Work Order ID 124690

Item ID: 646.3001 Accept ***N900040100*** Setup Start ***NS1***
Revision ID: Stop ***NS2***
Item Name: Lower Cutter Assy
Start Date: 9/22/2014 Start Qty: 2.00 ***2*** Cust Item ID:
Required Date: 9/22/2014 Req'd Qty: 2.00 ***2*** Customer:
Reference:

APICAL INDUSTRIES, INC.	ENGINEERING CHANGE NOTICE NO. 02195			SHEET 1 OF 4	
	DWG NO. 646.3000	REV: N/C	PREPARED BY S. HUFF	DATE: 01/05/09	EFFECT ON DWG ☐ INC. ☒ UNINC.
	DWG TITLE: LOWER CUTTER ASSY				
	APPROVED BY: ENGR <i>[Signature]</i>	MFG <i>[Signature]</i>	QC <i>[Signature]</i>	EFF: NEXT ORDER	
TRANSACTION CODES (TC): A-ADD C-CREATE R-REVISE D-DELETE	REASON: REMOVED RIVETS IN FAVOR OF ADDITIONAL SCREWS

SHEET 1, ZONE D5, IS:

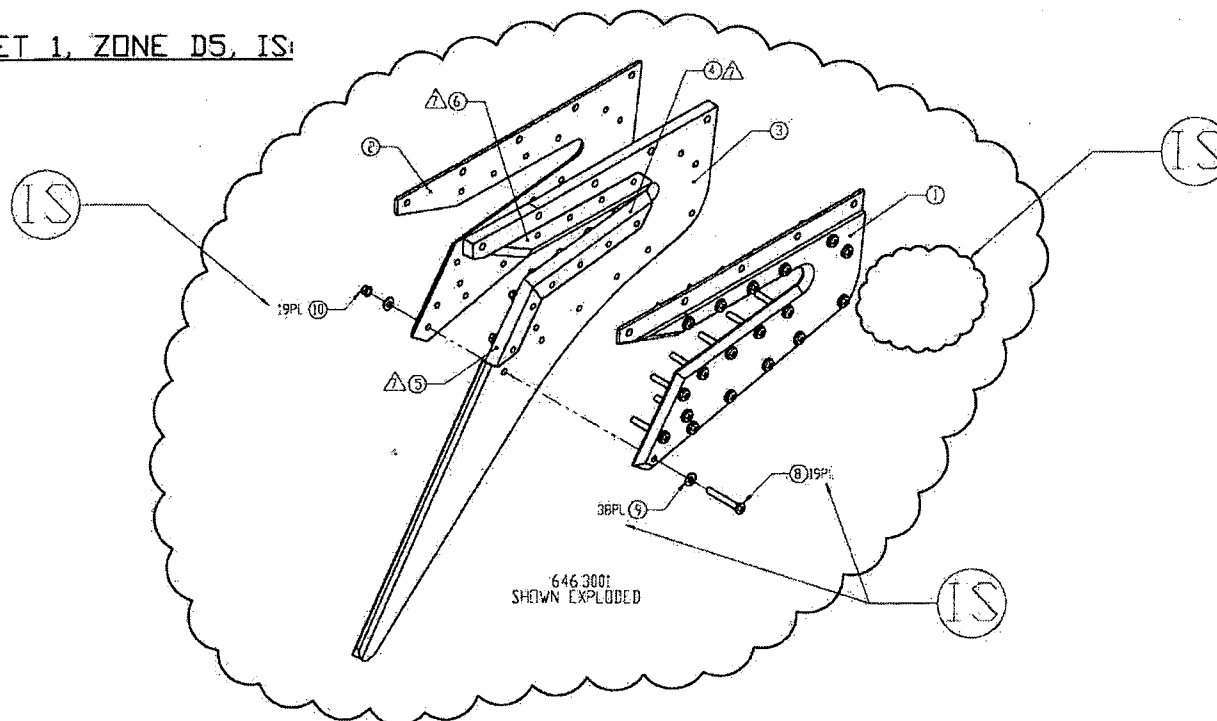
10	R	601.1541		19	LOCKNUT	MS21042L08	
9	R	601.2764		38	WASHER	NAS1149FN832P	
8	R	601.2765		19	SCREW	MS27039-0819	
7	D	601.2766		2	RIVET	MS20470AD5-18	
				.3001			
F/N	TC	PART NUMBER	QTY	DESCRIPTION		MATERIAL/SPECIFICATION	
DOCUMENTS EFFECTED:						CHANGE CATEGORY	DER REVIEW REQUIRED
☐ MDL ☒ INSTALL INSTRUC ☒ ICA ☐ FMS ☒ BOM						☐ MAJOR ☒ MINOR	☐ YES ☒ NO
